H[®] TECHNICAL BULLETIN

PRIMAAX[®] / FIREMAAX[®] Support Beam Assembly

SUBJECT: Discontinued Support Beam Assemblies

LIT NO: SEU-0229

FIGURE 1

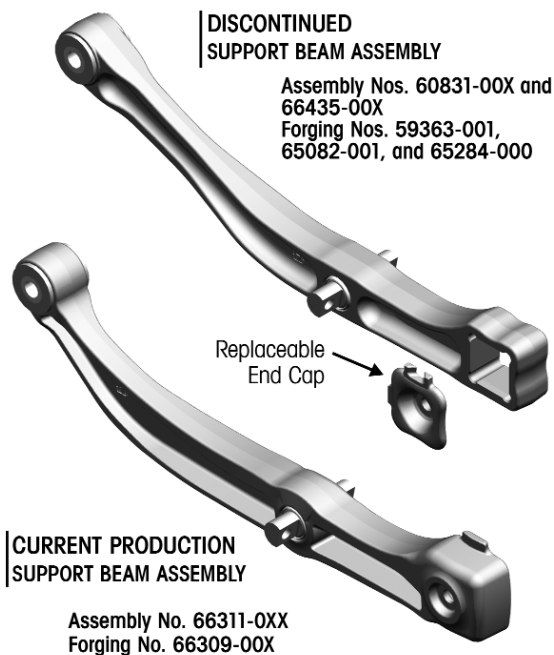
Effective May 1, 2010, support beam assembly part numbers 66435-00X or 60831-00X (Forging Part Nos. 59363-001, 65082-000, and 65284-000) for PRIMAAX[®] • FIREMAAX[®] suspension systems are discontinued for field service purposes for North and Central America, see Figure 1.

U-beam assembly service kits (part number 60961-XXX, see Figure 2) **must be** used for any necessary replacement of PRIMAAX • FIREMAAX support beam assemblies (part numbers 66435-00X or 60831-00X) in the field. Refer to Table 1 on page 3 to determine the U-beam assembly service kit for each respective vehicle manufacturer.

FIGURE 2

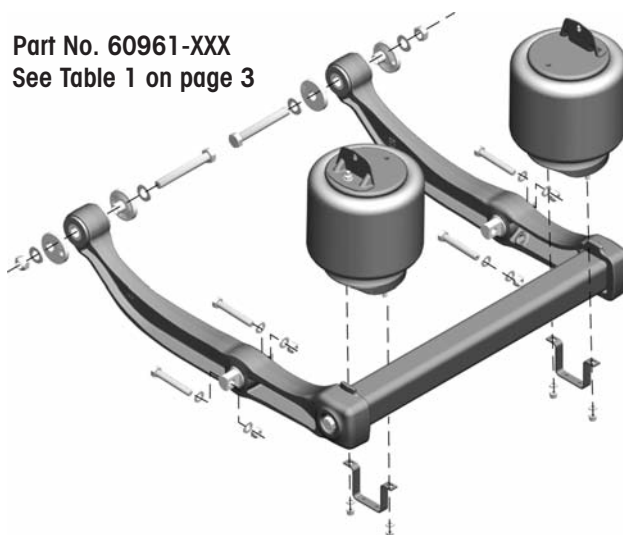
The U-beam assembly service kits (part number 60961-XXX, see Figure 2) are designed for the discontinued support beam assemblies and their related components on one axle and do not require additional drilling or modifications.

Each service kit, see Figure 2, is intended for servicing the associated suspension parts on one axle, and includes two new support beam assemblies, one cross tube, two air spring assemblies, air spring hardware, QUIK-ALIGN® hardware and D-pin hardware.

FIGURE 3

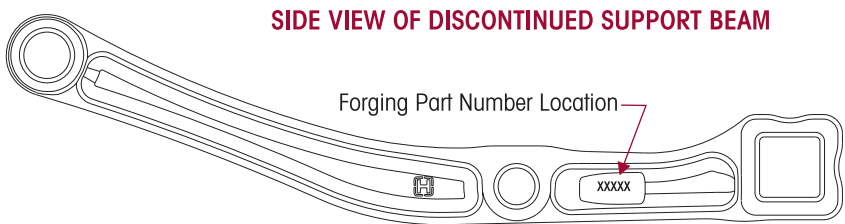
The support beam forging number, see Figure 3, can be used to help identify the support beam assembly part numbers and the U-beam assemblies that contain them. Support beam assembly part numbers **are not** shown on the beam.
